ALABAMA DEPARTMENT OF TRANSPORTATION CONSTRUCTION BUREAU

Construction Information Memorandum No. 4 - 2020

RE: Revision of Special Project Detail 325 Guardrail Height Adjustment
Pay Item 631C Guardrail Reset

GUARDRAIL HEIGHT ADJUSTMENT (USING ADJUSTMENT HOLES)

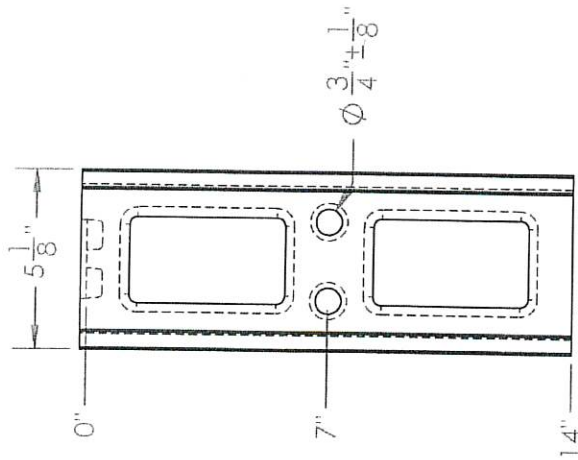
Along with the attached July 17, 2020 emails, the Design Bureau distributed a revised version of Special Project Detail 325 with changes and clarifications related to guardrail height adjustment. A detailed drawing of the Mondo GB14SH1 composite guardrail blockout was also distributed.

- 1) Currently, the only composite blockout approved for use with the resetting of guardrail is the Mondo GB14SH1, which is shown in List II-17 of the MSDSAR Manual under the new heading **MASH TL3 Adjustable Height Compliant**. New wood blockouts are also MASH compliant.
- 2) Only one bolt is required to attach guardrail at each post. The previous drawing showed two bolts per blockout for the 4" adjustment. Only one bolt was intended to have gone through the rail.
- 3) Existing hardware (bolts, nuts, washers) may be used if in good condition, as determined by the Engineer.

I was in error in 2a) below, the replacement of blocks is to be included in the reset pay item. See note 9 in the drawing.

The Special Project Detail for Guardrail Height Adjustment has been revised. There were several inconsistencies and unclear language that has now been updated. Things to note are:

- 1) The original blockouts on an installation can only be retained if they are wood or Mondo composite. All other types (including King composite and steel) MUST be replaced as part of the raising. I have attached the manufacturer's details for one of the Mondo blocks for your reference.

- 2) The designer needs to be VERY clear in the box sheet what is required as part of the raising. This includes, but is not limited to:
 - a. Block Replacement (paid separately from the raising)

- b. What height is being raised (this will affect which holes are to be drilled, see (3) below).
- 3) There is only one bolt required for the raising, therefore the drawing has been revised to show only one series of new holes in the guardrail post, and then only the holes that are needed (either at the 2" raising level or the 4", but not both). The required bolt can be the original bolt if it is serviceable.

- 4) This drawing reflects the requirements for raising guardrail in accordance with a system MASH crash-tested and compliant. ANY change to this drawing will render the system as NON-MASH compliant.

The revised drawing is applicable to all on-going projects. These drawing revisions will not result in any additional work or materials; therefore, no cost increase will be due to the Contractor.
